**MINUTES OF THE REGULAR MEETING OF THE DESIGN REVIEW COMMISSION OF THE CITY OF LOS ALTOS, HELD ON WEDNESDAY, NOVEMBER 3, 2021, BEGINNING AT 7:00 P.M. HELD VIA VIDEO/TELECONFERENCE PER EXECUTIVE ORDER N-29-20**

**2. SC21-0026 - Safaei Design Group - 120 Coronado Avenue**

Design Review for a new two-story house. The project includes a 2,553 square-foot at the first story and 1,400 square feet at the second story with a 2,413 square-foot basement . The project includes an 800 square-foot detached accessory dwelling unit, which is not part of the design review application. This project is categorically exempt from environmental review under Section 15303 of the California Environmental Quality Act. *Project Planner: Gallegos*

**PROPOSED SITE PLAN - SCALE: 1/8"=1'-0"**

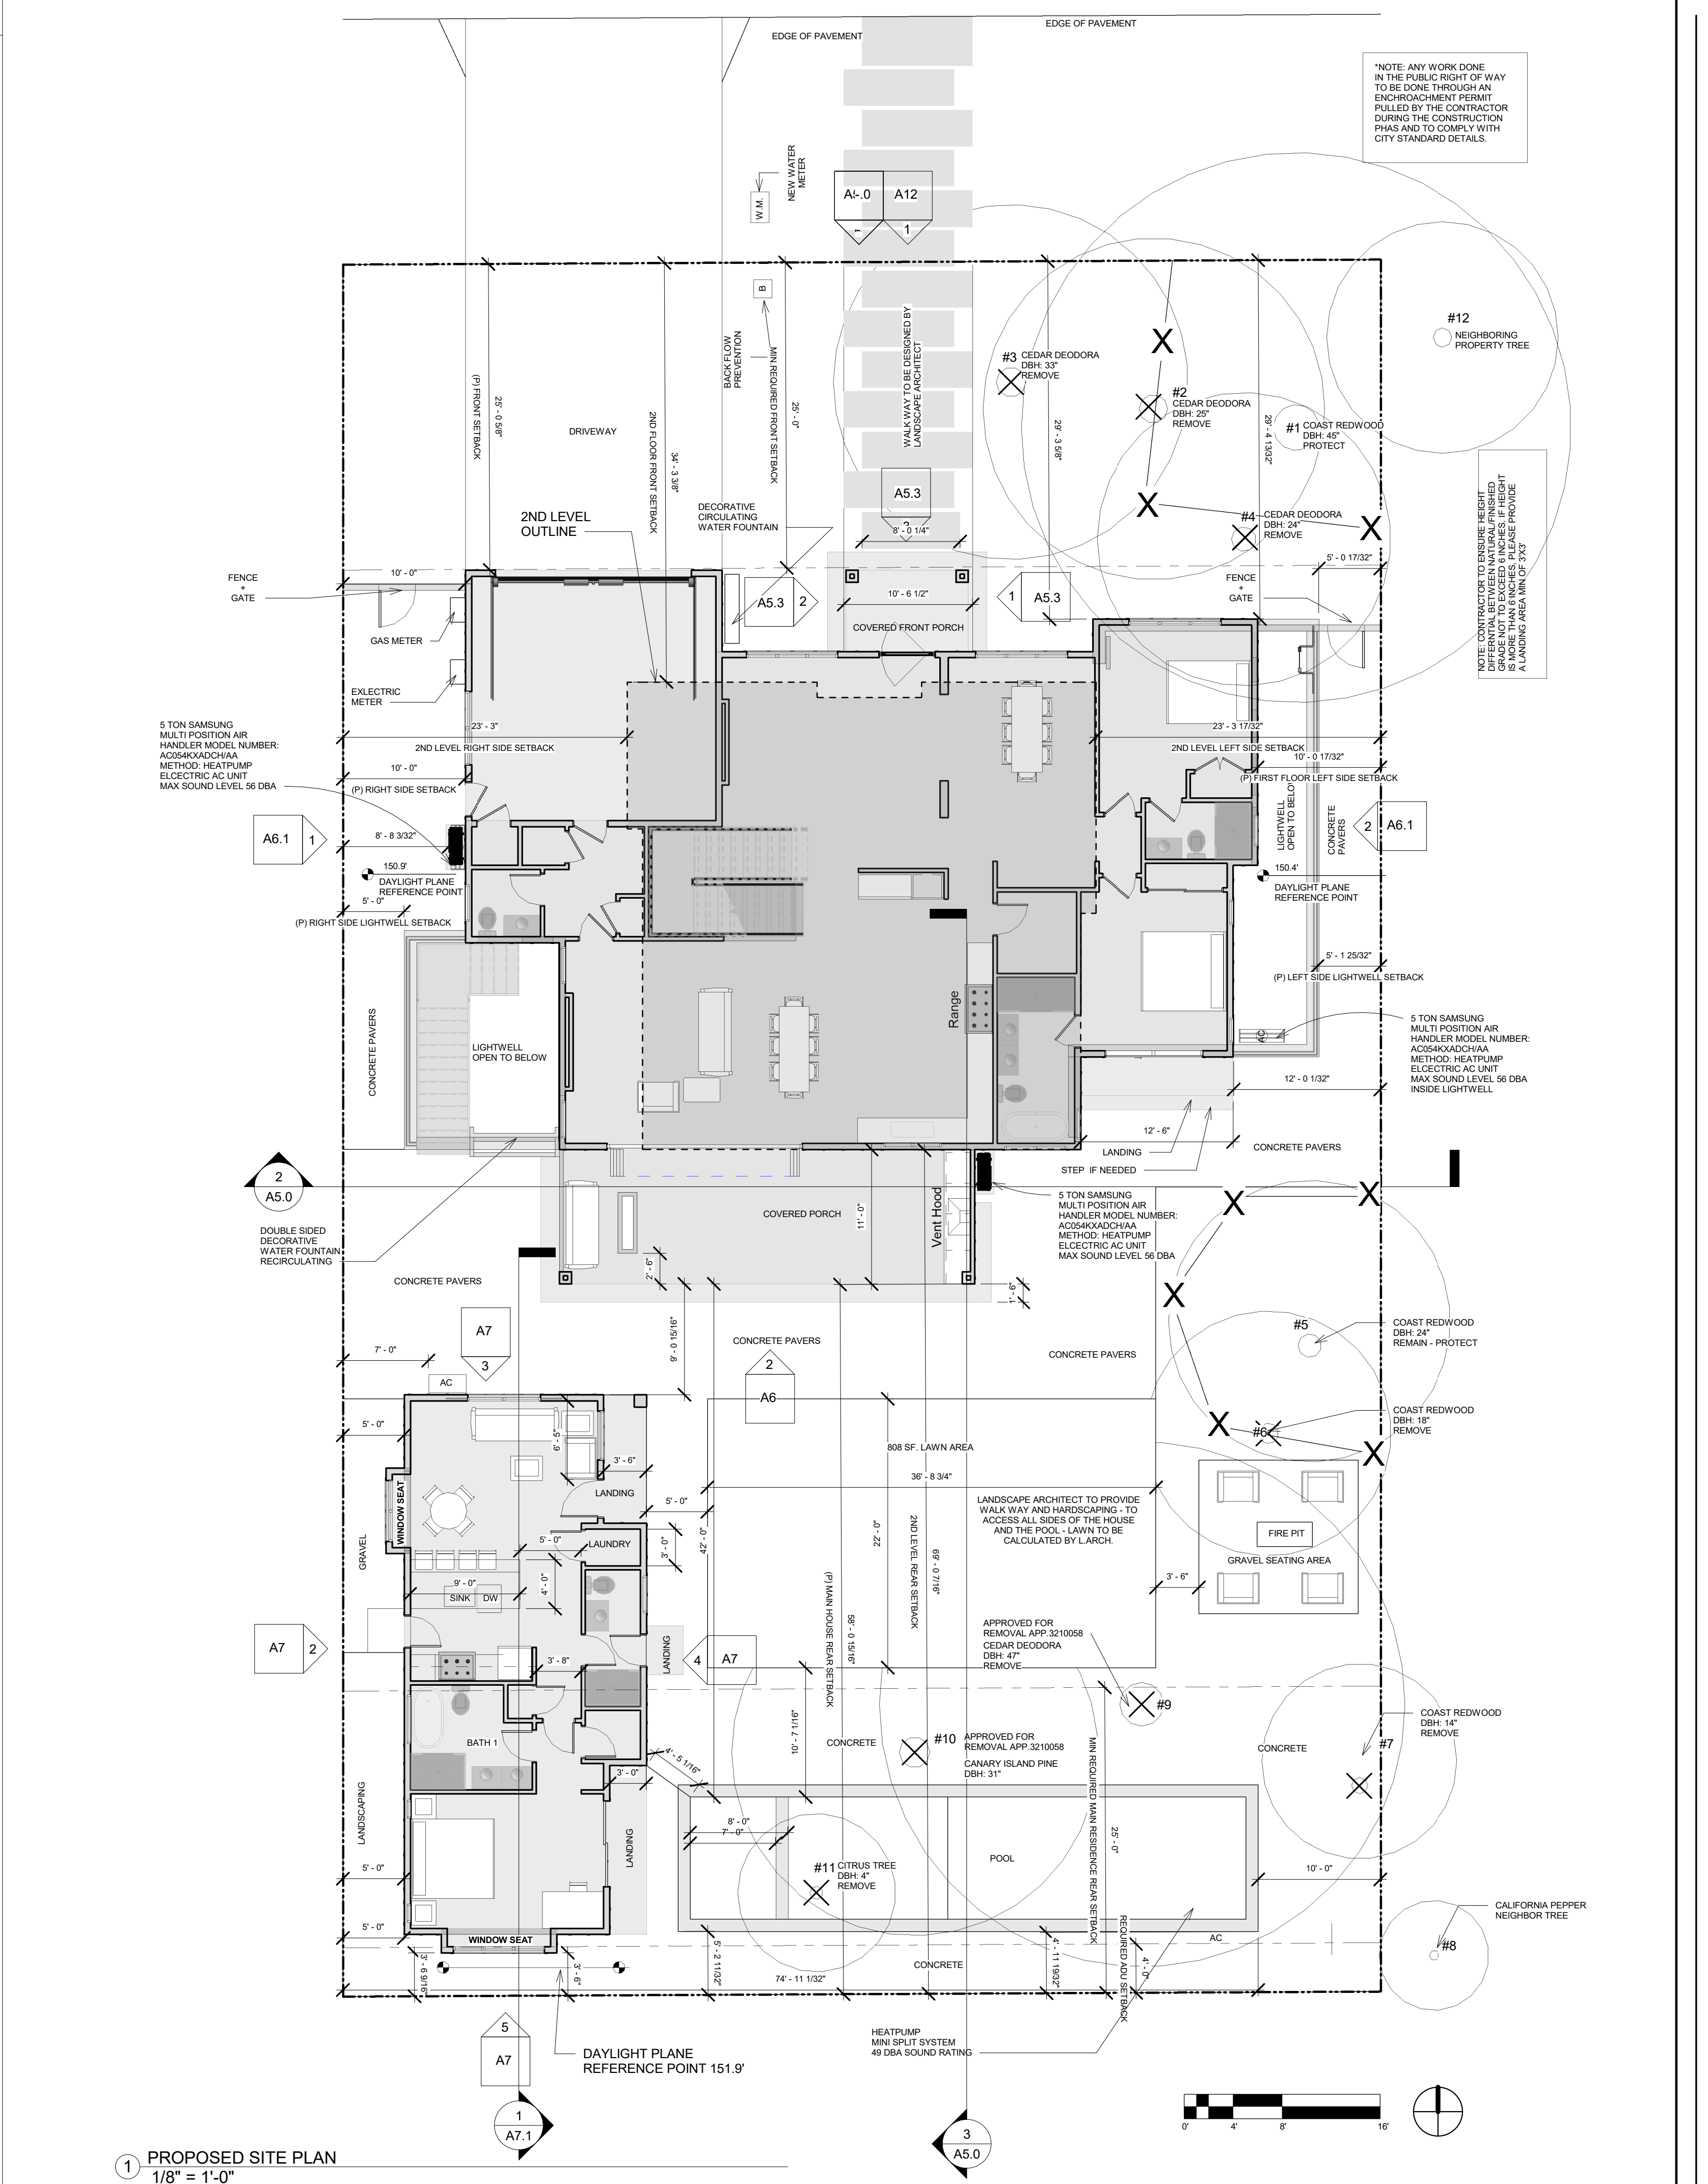
Location of pool equipment enclosure has been indicated on sheet A2

Sheet a2 has been updated to indicate the size and location of new side and rear goodneighbor fence to be 6' tall with 2' lattice on top. This detail has been provided on sheet AD2: details 1 and 2

A2.2

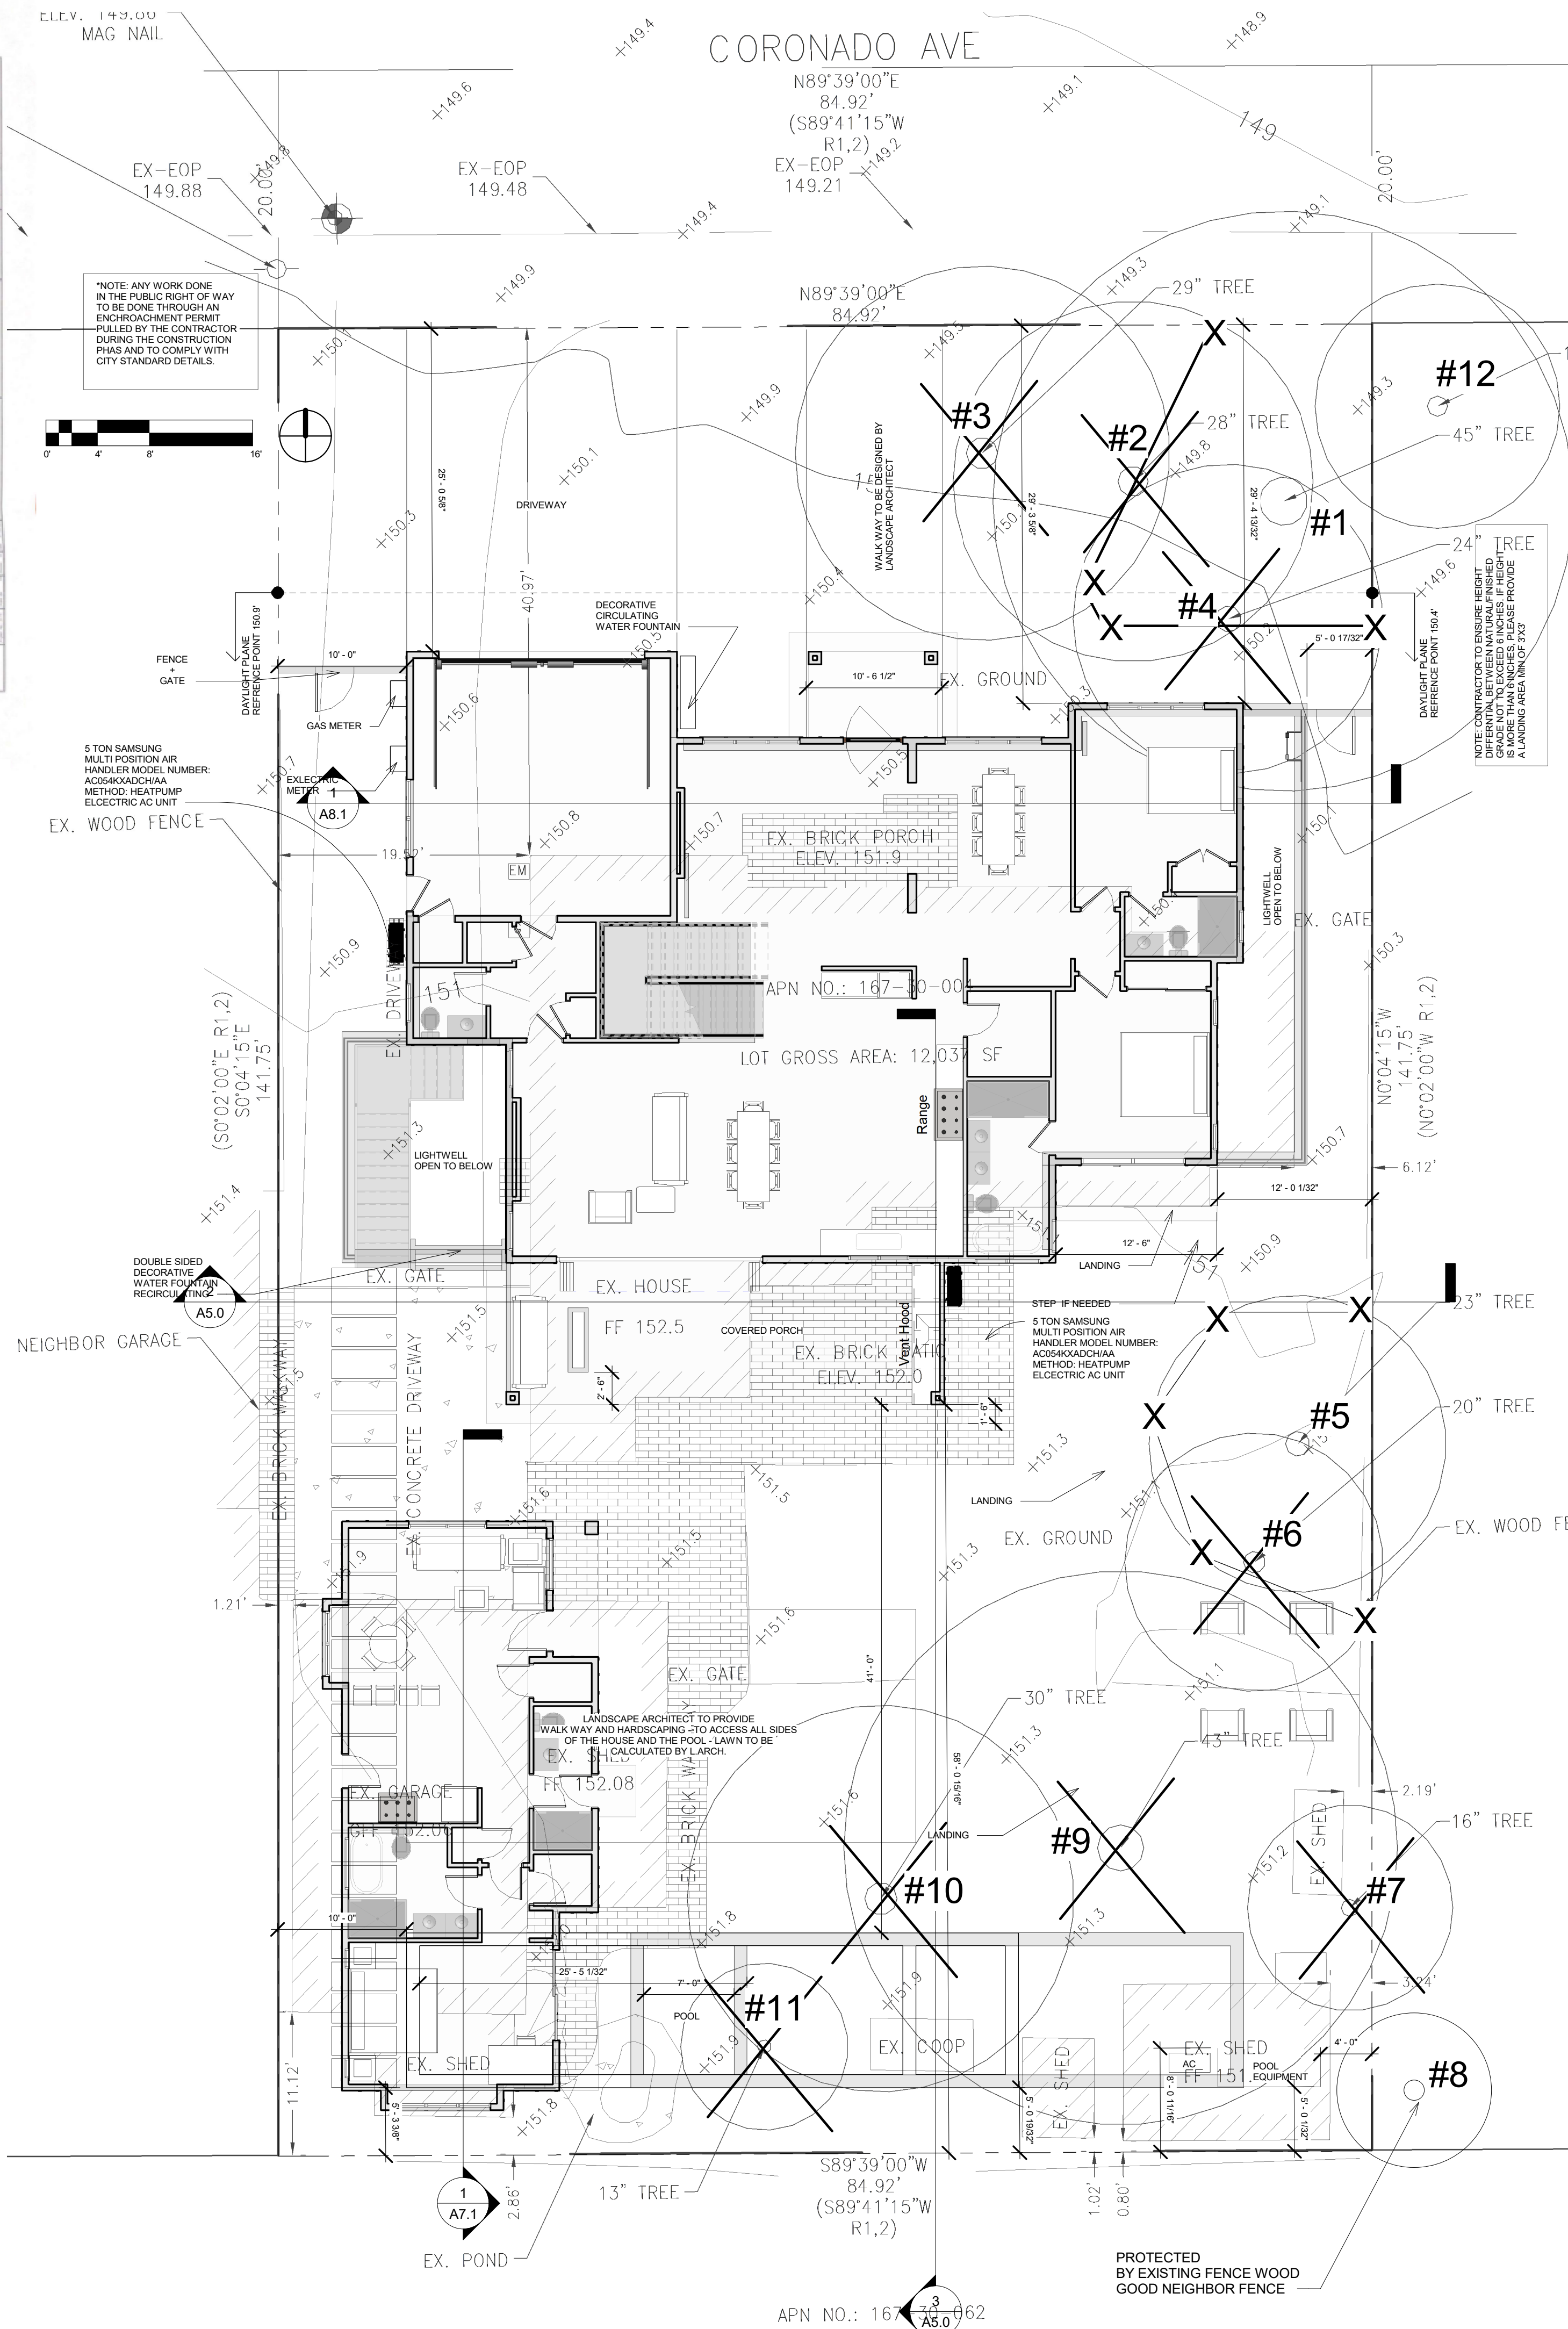
Trees Nos. 3, 6 and 9 shown to be removed on plan Sheet A2.2 of the approved set of plans are hereby approved for removal. Tree removal shall not occur until a building permit is submitted and shall only occur after issuance of a demolition permit or building permit. Exceptions to this condition may be granted by the Community Development Director upon submitting written justification.
